AMENDMENTS TO THE DRAWINGS

Appl. No. 10/672,835
Amdt. Dated June 6, 2006
Reply to Office action of Apr. 6, 2006

Annotate Sheet Showing Changes

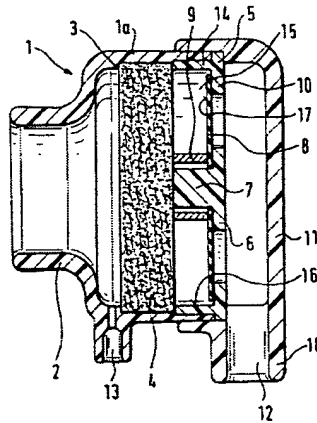
The attached sheet of drawings includes changes to Figure 1. This sheet, which includes Figure 1, replaces the original sheet including Figure 1. In Figure 1, the previously omitted elements 15 and 16 have been added.

Regarding the Examiner's rejection of the drawings under 37 CFR 1.83(a), the Applicants submit a revised drawing to include the oxygen apparatus as called for in claim 1 and an external humidifier as called for in claim 2. The Applicant notes that 37 CFR 1.83(a) provides that "conventional features disclosed in the description and claims, where their detailed illustration is not essential for a proper understanding of the invention, should be illustrated in the drawing in the form of a graphical drawing symbol or a labeled representation (e.g., a labeled rectangular box)." The Applicant respectfully asserts that the claimed oxygen apparatus and external humidifier are conventional features which are disclosed in the substitute specification in the second full paragraph on page 3 and the first full paragraph on page 5, respectfully. Accordingly, the Applicant hereby amends the drawing to illustrate the oxygen apparatus and the humidifier in the form of a labeled representation, in accordance with 37 CFR 1.83(a). The applicant also amends the description on pages 4 and 5 to include the new reference numbers assigned to the oxygen apparatus (15) and humidifier (16).
